Docket Item #12
BAR CASE #2005-0117

BAR Meeting
June 1, 2005

ISSUE: Alterations

LOCATION: 215 Jefferson Street

Figure 2 - West side elevation showing proposed alterations to the addition

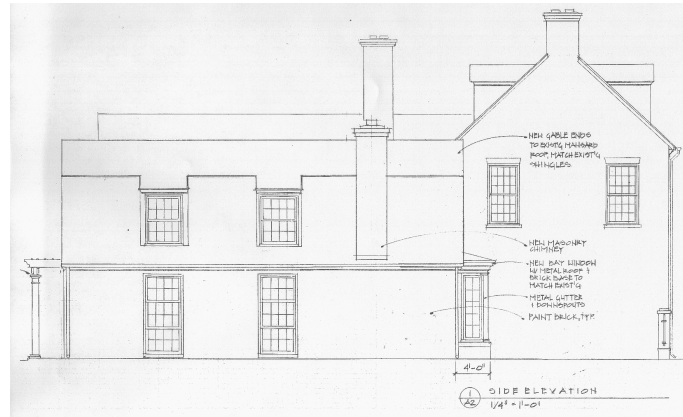
The new square bay will project 4" from the front of the hipped roof addition. It will have a single 10-light window in the west side elevation. A new brick chimney will be located toward the south end of the hip roof. The clipped gable on the hipped roof section will be eliminated and roof will be extended forward to end flush with the front wall. The new roof area will be clad in slate shingles to match the existing.

Figure 4 - Proposed shed

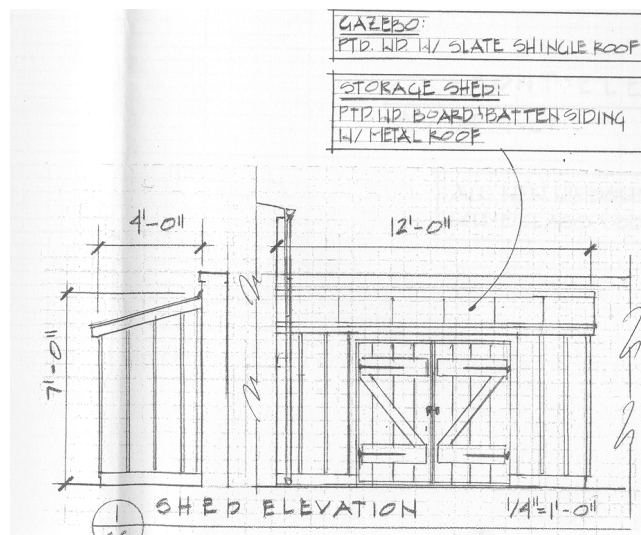
A new storage shed is proposed to be constructed in the northwest corner of the yard against the brick wall along the rear property line. The shed will face south, towards the back of the house. It will be 12' long and 4' deep and will have a shed roof. The shed will be 7' high at its highest point, approximately 1' lower than the brick wall behind it. It will be clad in wood board-and-batten siding and will have a standing seam metal roof. There will be a pair of double doors with strap hinges in the center of the shed's south elevation.

- F-1 The proposed shed is located within 5 feet of the interior lot line and shall comply with C-1 below.

- C-1 All exterior walls within 5 feet from an interior property line shall have a fire resistance rating of 1 hour, from both sides of the wall. As alternative, a 2 hour fire wall may be provided. This condition is also applicable to skylights within setback distance. Openings in exterior walls between 3 and 5 feet shall not exceed 25% of the area of the entire wall surface (This shall include bay windows). Openings shall not be permitted in exterior walls within 3 feet of an interior lot line.

Figure 5 - Proposed gazebo

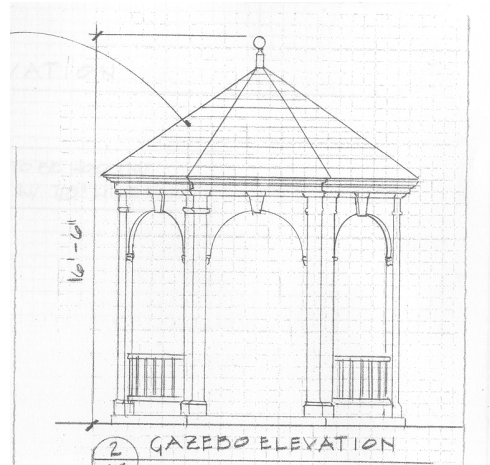
A new gazebo is proposed for an area near the northeast corner of the yard. It will be octagonal with a slate roof and wood railing, supports and trim. The gazebo will be 12' across and 16.5' high at the top of the finial on the roof. Both the gazebo and shed will be painted.
